# MISSISSIPPI POWER & LIGHT COMPANY

SUBJECT: Grand Gulf Nuclear Station  
Units 1 and 2  
Docket Nos. 50-416 and 50-417  
License No. NPF-13  
File: 0260/L-860.0  
Additional Information - TDI Engine  
Inspection  
AECM-84/0386

Mississippi Power & Light (MP&L) provided by AECM-84/0373, dated July 20, 1984, responses to the NRC request for additional information dated July 17, 1984. One item, D.9, was noted to be provided in a later submittal. Attached is a revision to Attachment 1 of AECM-84/0373 which includes a response to item D.9 and also provides supplemental information on various other items. The Augmented Maintenance/Surveillance Program, attached as Table A-1, has also been modified to add an inspection of the engine fuel oil piping system. Each change or addition is denoted by a bar in the margin.

TABLE 1  
Cylinder Head Baseline  
Data for Flatness

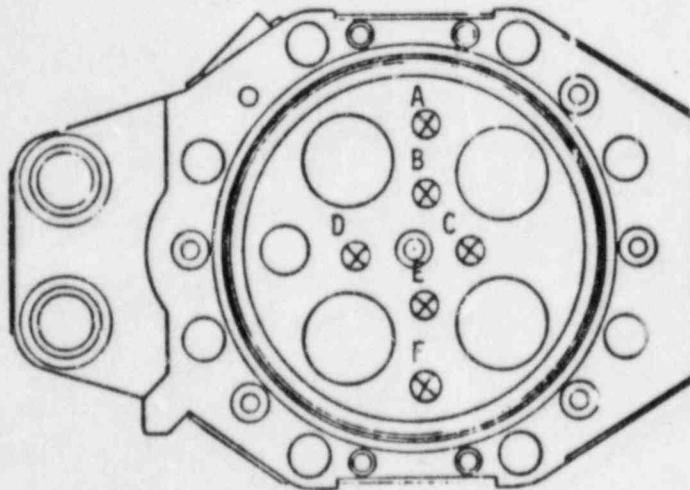
4. Documented results of measurements of the cylinder head fire deck surface flatness.

A straight edge and micrometer were utilized to obtain baseline information for the cylinder head fire deck profiles. Measurements were taken at six different locations on the fire deck. Readings varied from head to head as to the depth of the fire deck depression. Results of the measurements are shown in TABLE 1.

Changes in readings taken across the fire deck were due to the curvature of the fire deck and were consistent for all heads and did not indicate a problem with head warpage. These readings were taken for baseline data to be used in the future to determine if warpage of the heads may have occurred.
